**Re: Hanlon Creek Business Park Environmental Implementation Report  
Outstanding Items**

# **Agency and Environmental Group EIR Comment Table**

Pedestrian and Open Space Trail System

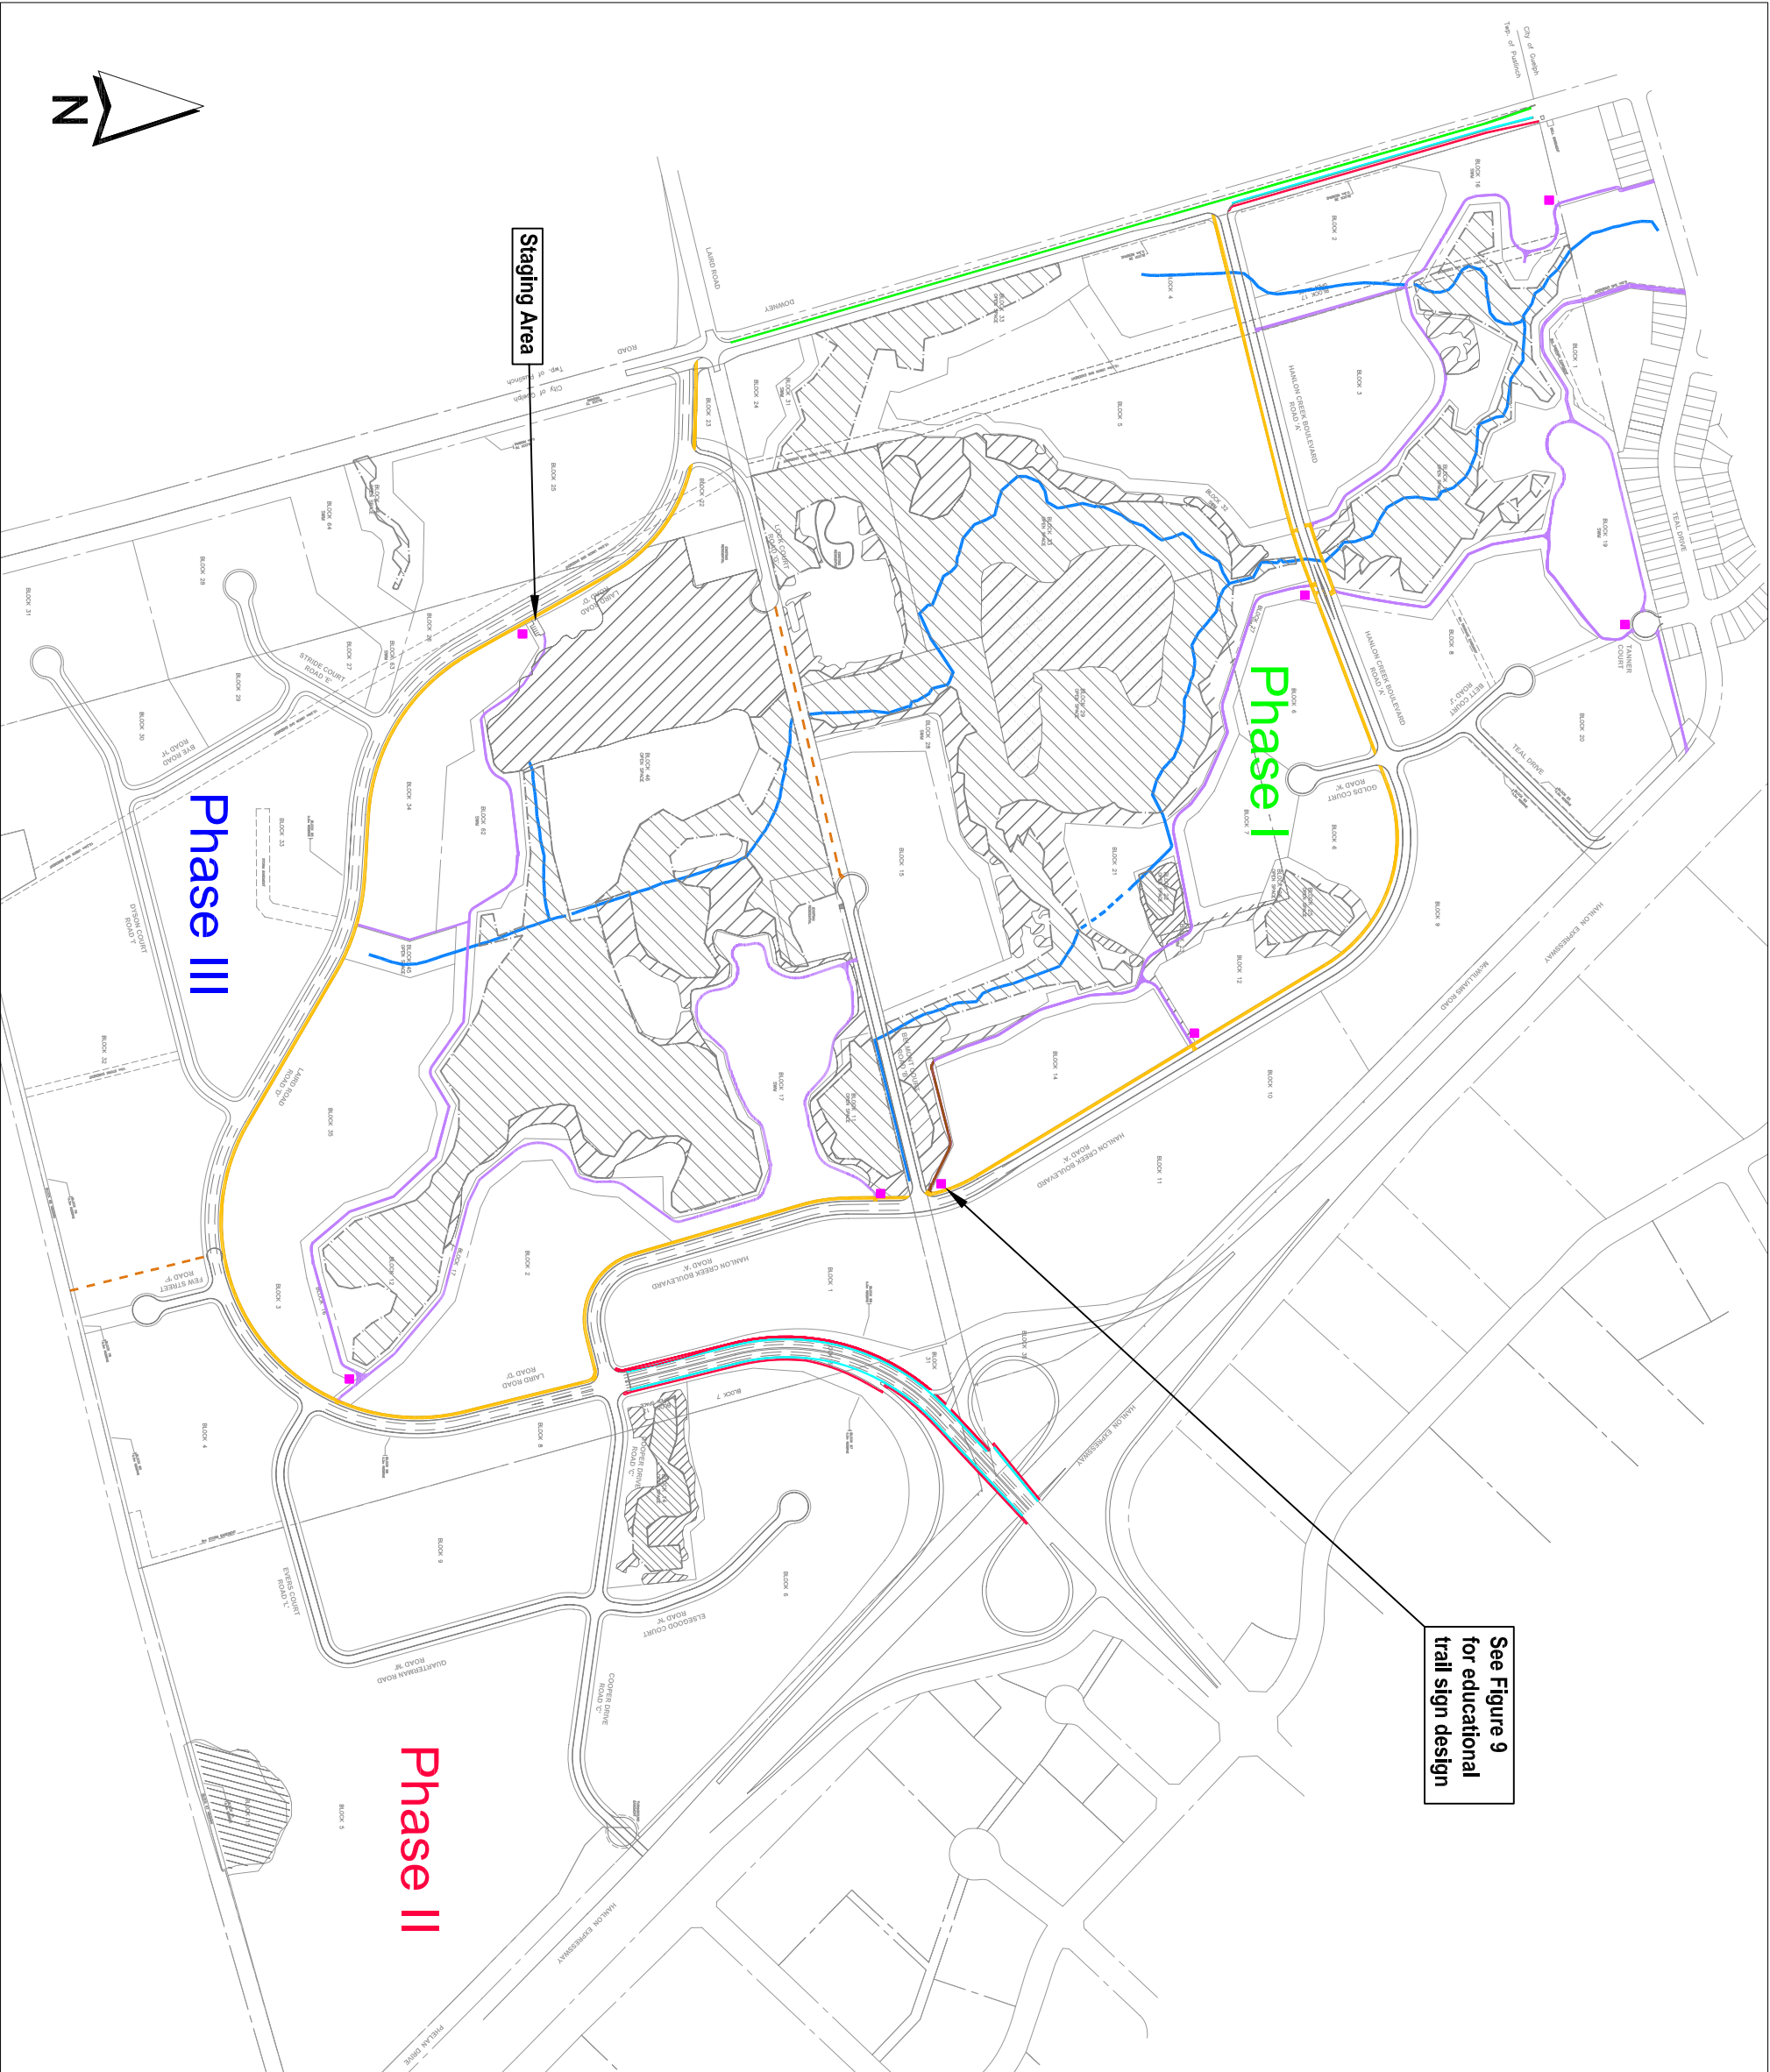
4	Confirmation of trail materials	I could not find any reference in the NRS's response re confirmation of trail materials	HCBP EIR Section 9.0 Pedestrian and Open Space Trail System (NRSI 2009), Figure 8.  a) off-road bike trail (southern portion of Block 14) - wood chip b) on-road bike trail - asphalt c) off-road trail - limestone screenings d) multi-use trail - asphalt

Figure 2

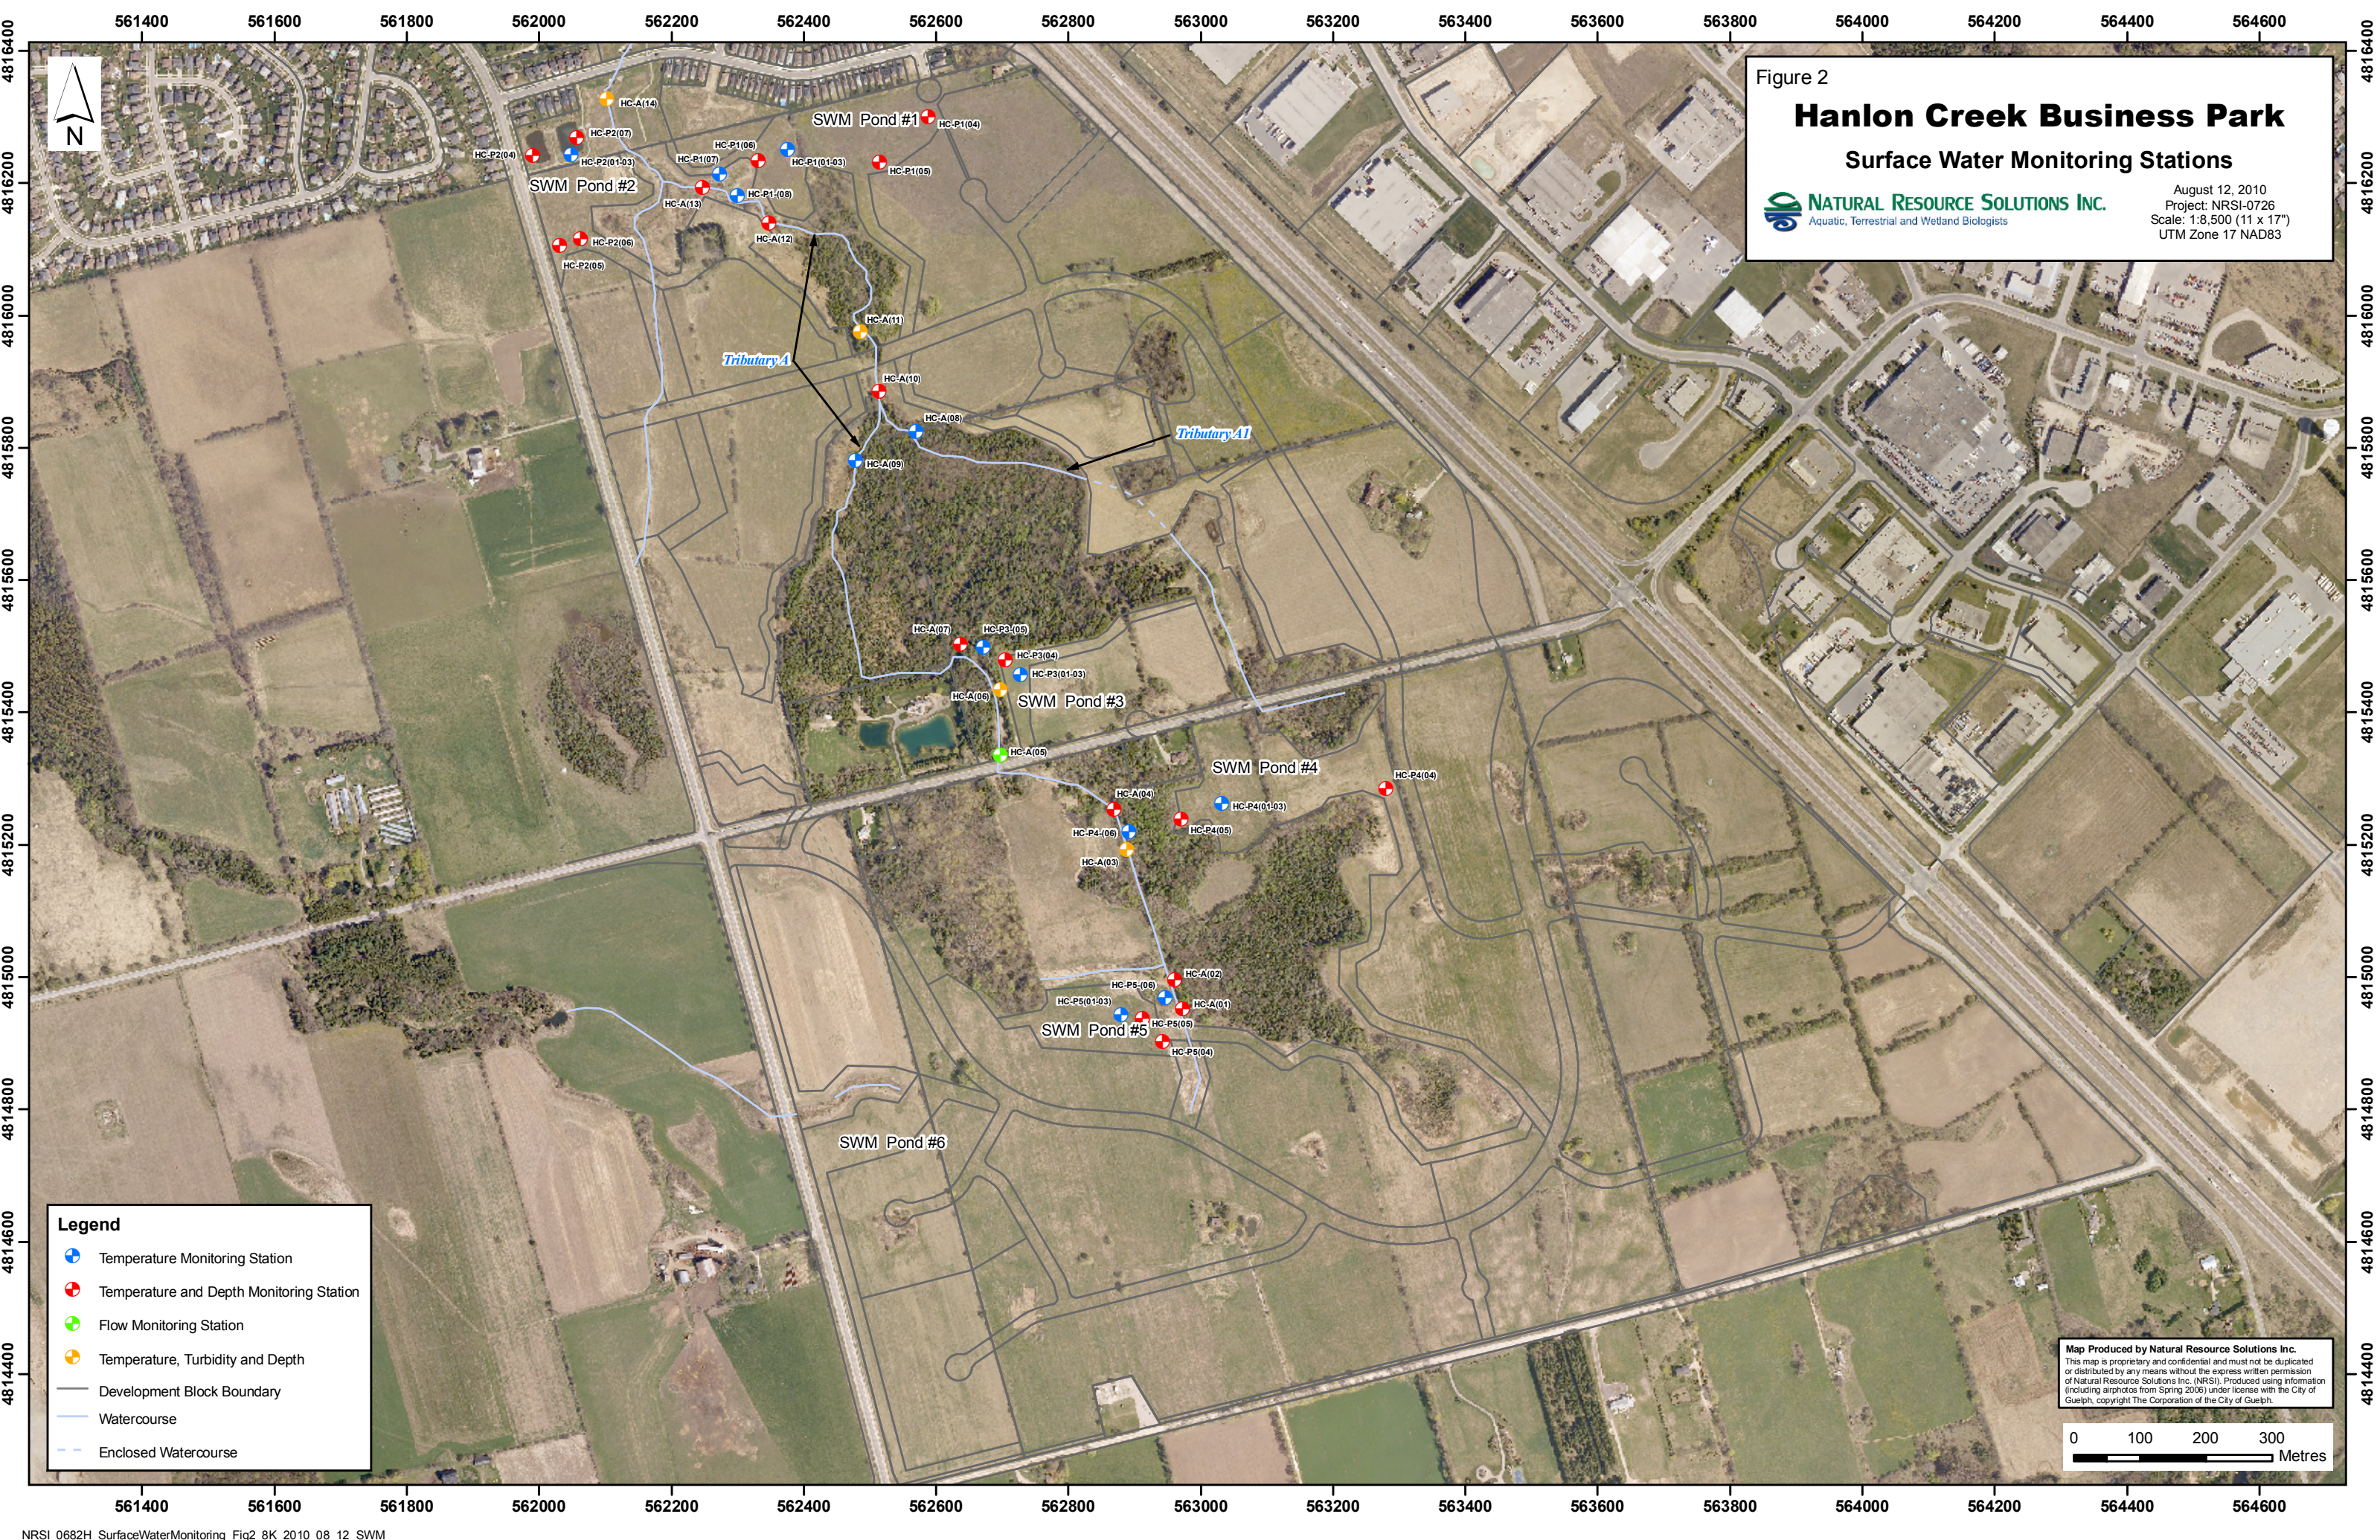
b) Page 11, Section 4.2 - Add that environmental inspections will occur weekly as per OMB Condition 10.	This item has been added as requested.	
		c) Page 16, Section 6.1 - Logger measurement frequency needs to be specified. The wells to be abandoned and the replacement monitoring wells should be identified and labelled on Figure 1.	The logger measurement frequency is indicated as "...daily, or more frequent basis..." in the frequency section of the SOPs for groundwater.	Appended to EIR Package - Figure 2 Hanlon Creek Business Park Surface Water Monitoring Stations

### **5. Creek crossing and culvert on Road A**

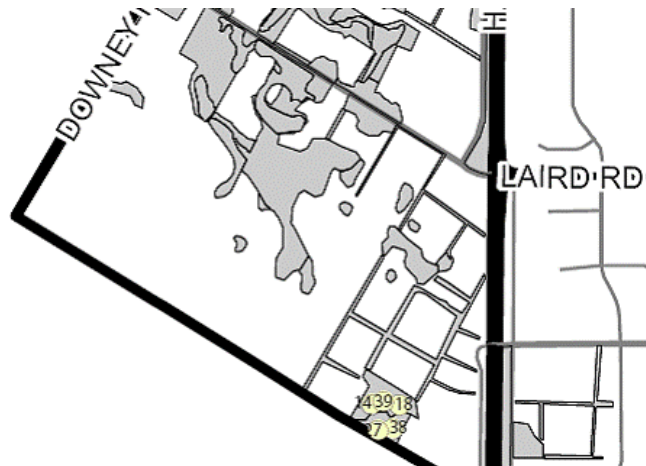
The EIR proposes a 34m culvert (page 109). Why is such a long culvert needed? This was to be a two-lane road. The break in habitat north and south of the road will be even greater than that. This is at odds with our previous discussions with the consultants.

At EAC we discussed the possibility of narrowing the road at that point. We also asked them to examine a bridge instead of a culvert and this was mentioned in the EIS. Clearly this was not considered and not discussed in the EIR.

**Figure 1 - KMUD sensitivity analysis time series for Pond 4 compared to the Max-Becker pond maximum temperatures (°C) for the 02/Aug/2006 precipitation event**

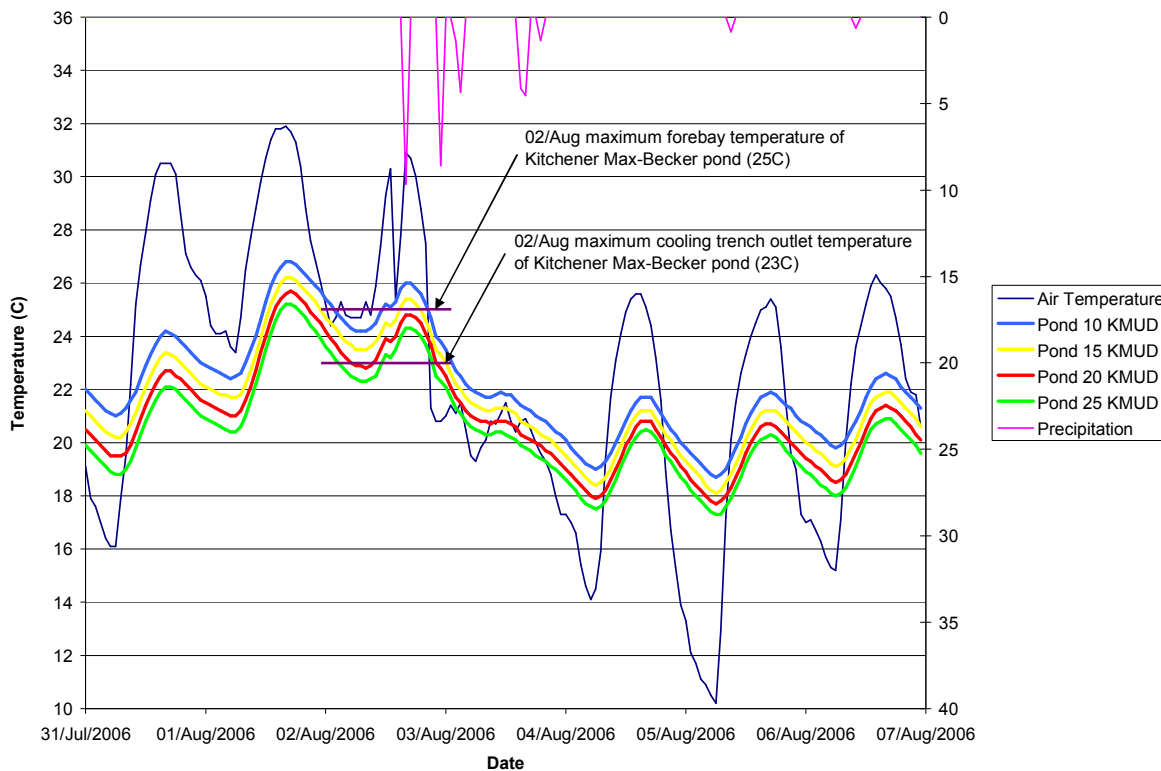
The Max-Becker pond in Kitchener is similar in design to the proposed SWM ponds for the HCBP. It features a bottom-draw outlet structure that flows into a cooling trench before being released to the receiving watercourse. Recent monitoring results summarize the water temperature time series of several locations within the pond: the inlet sediment forebay, the bottom-draw outlet, and the outlet of the cooling trench. In order to compare modelled temperatures to monitored data, we compare the temperatures from the Max-Becker pond monitoring to a storm event experienced during a hot day in

As is demonstrated in the above graph, the simulated pond temperatures are within a degree of the observed temperatures at the Max-Becker pond, and have overestimated the maximum temperatures of that warm precipitation event. Therefore, the results presented in the Stream Temperature Impact Report offer a conservative, and accurate, representation of pond performance using the KMUD parameter.

**Figure 2 - Stream temperature upstream and downstream of Pond 4 for the 02/Aug/2006 precipitation event**

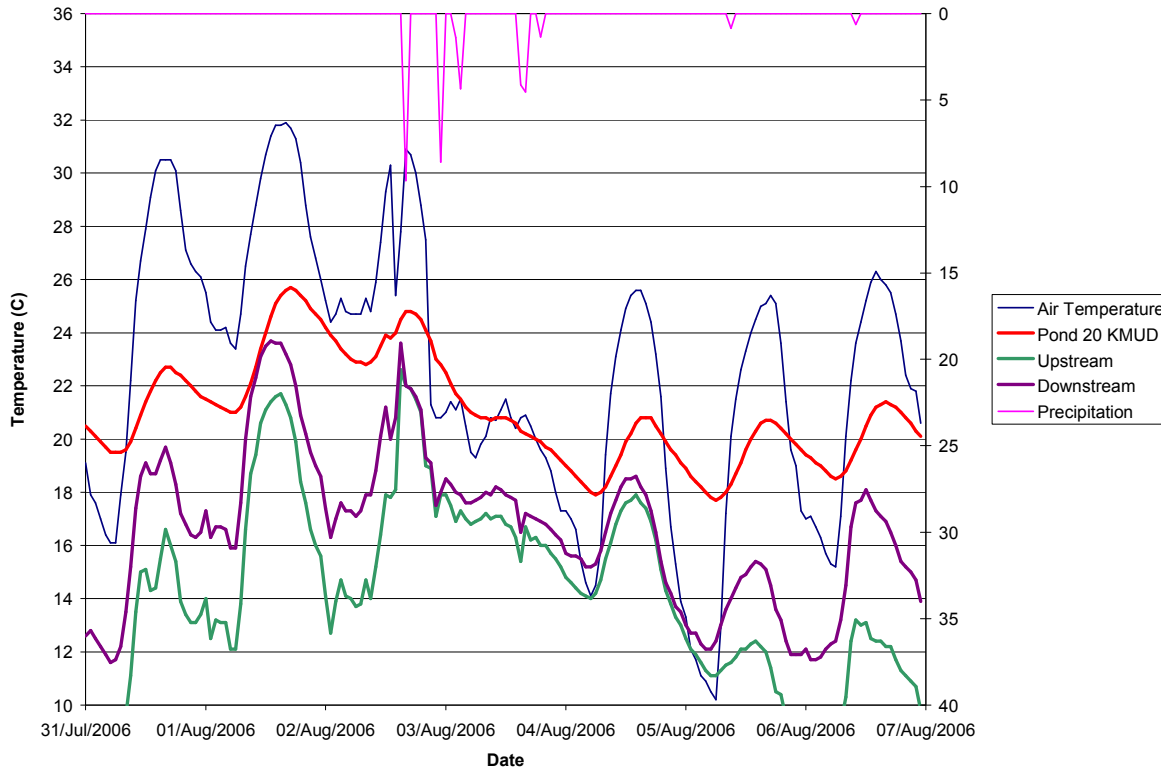
The concern brought forth by the GRCA is that the discharge from the SWM ponds will be so great during storm events that it will overwhelm the regular creek flow and cause a significantly warming effect. In the previous section the Max-Becker pond in Kitchener was referenced, and during the August 02, 2006 precipitation event, which followed the hottest day of the 2006 summer season, the maximum cooling trench outlet temperature was approximately 23°C. It was demonstrated that the

It becomes clear that the pond discharge does have an effect on the water temperature in the stream; however, the precipitation brings about a significant cooling effect after being routed through the mitigated SWM pond. A summer precipitation event is almost always accompanied by heavy cloud cover and a significant drop in air temperature, which contribute to cooler stream temperatures. HSP-F determines the temperature of precipitation using the ambient air temperature, which is a conservatively warm estimate compared to reality (where precipitation temperature is based on the wet-bulb temperature). Therefore, during the warm summer months, precipitation is usually comparatively cool, and though large volumes of it are entering the stream due to the impervious watershed, the runoff does not appear to significantly influence the temperature regime of the stream.
